PLANNING, ZONING, & BUILDING DEPARTMENT
PZ&B Staff Memorandum: Landmarks Preservation Commission

SUBJECT: COA-24-007 (ZON-24-028) 124 VIA BETHESDA (COMBO)

MEETING: FEBRUARY 21, 2024, LPC
MARCH 13, 2024, TC

- The application is for the installation of two (2) sliding vehicular gates with a height of approximately 7'-8¼" (at the property's north motor court):

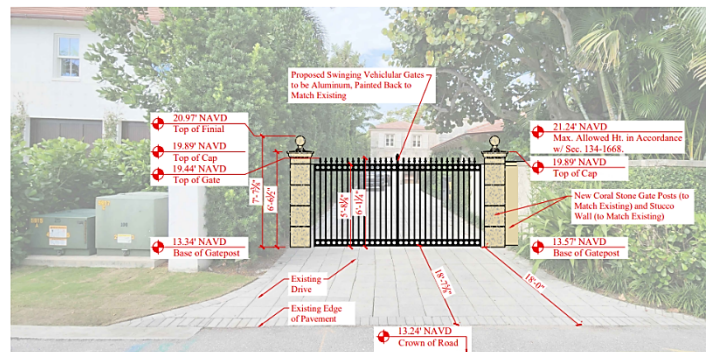
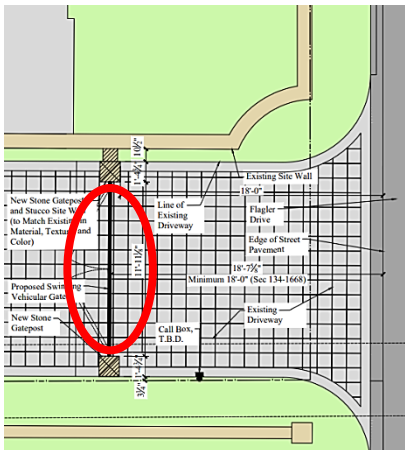
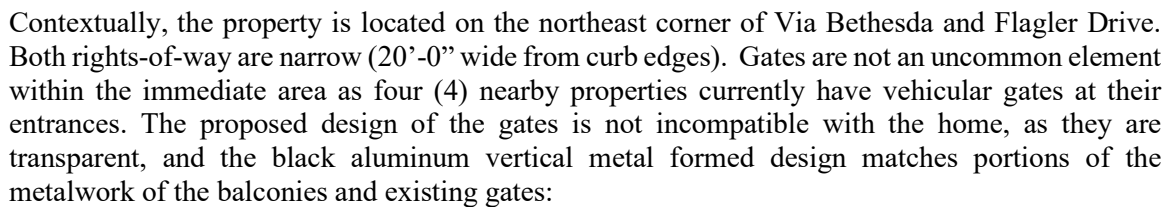
The application is seeking a Certificate of Appropriateness for the introduction of three (3) vehicular gates on a site that contains a landmarked property. The proposed design of the vehicular gates at the property's north motor court maintains the existing historic site wall and post layout that is constructed of natural rusticated Cuban coral. The majority of the site walls and posts appear to retain their original configuration and design except for a portion of the site wall on the northwest corner of the property where additional height was added to the original site wall (depicted in the photo). Two (2) sets of identical black aluminum gates are proposed that incorporate designs from existing railings and gates at the property. The new vehicular gate at the property's east driveway will include two (2) new gate posts and a stucco site wall that will attach to the existing site wall. The post design includes coral

This property was landmarked in 1990 due to its unique architecture and association with Howard Major. A preliminary review of the project, as proposed, appears to be inconsistent with the abovementioned sections of the Town zoning code as it pertains to the backup distance in conjunction with the new gates.
